OLDE ORCHARD ELEMENTARY SCHOOL

**Re: Construction Storm Water Inspection at Olde Orchard Elementary School
Franklin County
Permit Number: 4GC03314*AG**

Figure 1

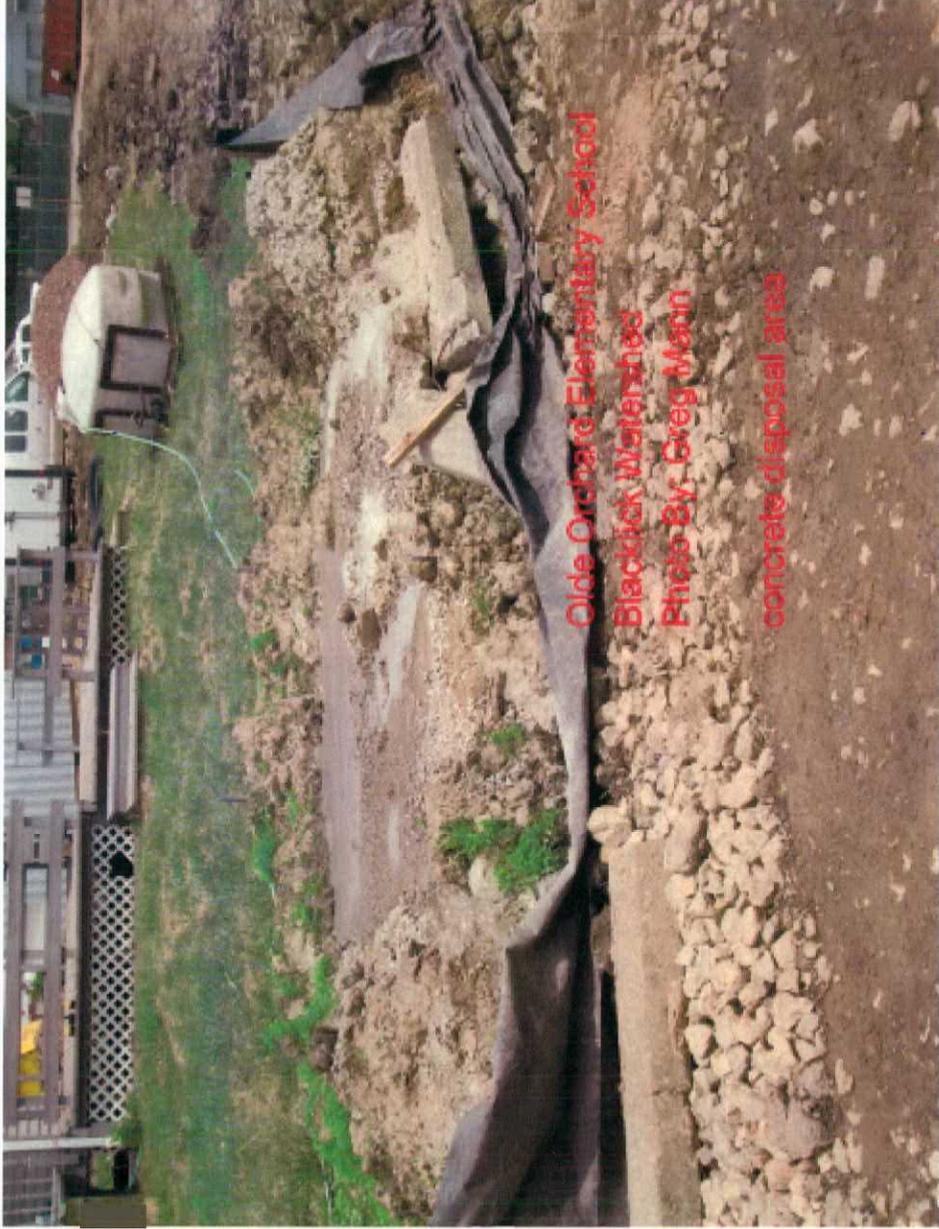
- Our staff observed an area of concrete disposal that lacked proper containment (Figure 1). If future onsite disposal is required, containment measures such as a pit impoundment is expected.
- The sediment and erosion controls, aside from the concrete disposal area, are currently functioning properly. Please continue to monitor and ensure continued compliance with the General Storm Water Permit Associated with Construction Activities.
